**Blendon Township
PORT SHELDON STREET – SHARED USE PATH
ADDENDUM No. 1**

Notice to All Prospective Bidders

Addendum No. 1

BLENDON TOWNSHIP
PORT SHELDON STREET SHARED USE PATH

CONCRETE PATH

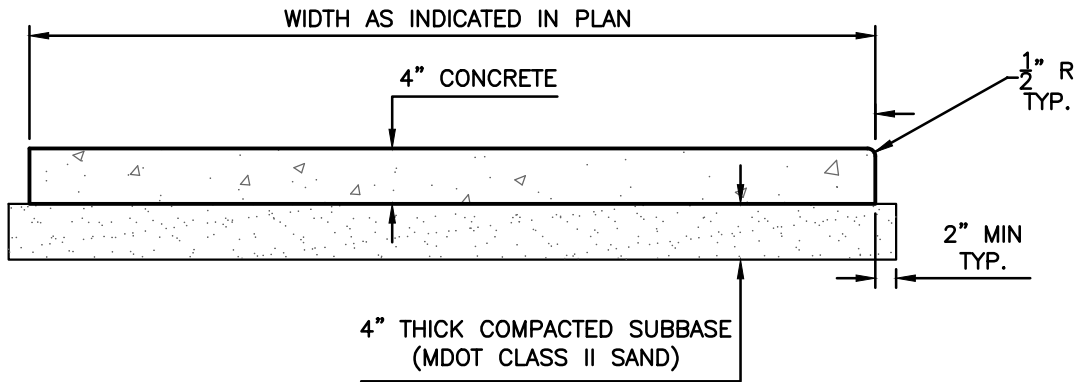
1. **Concrete Pathway** - Detail is added to the plan set (attached)

25. **Bid Alternate 1 - Install Path as Concrete:** Will be paid for as a lump sum Add or Deduct to the Base Bid to install a 4 inch concrete surface in lieu of the HMA surface included in the Base Bid. Add / Deduct to include increase in sand subbase material and decrease in aggregate base material included in the **Shared Use Path Grading** pay item.
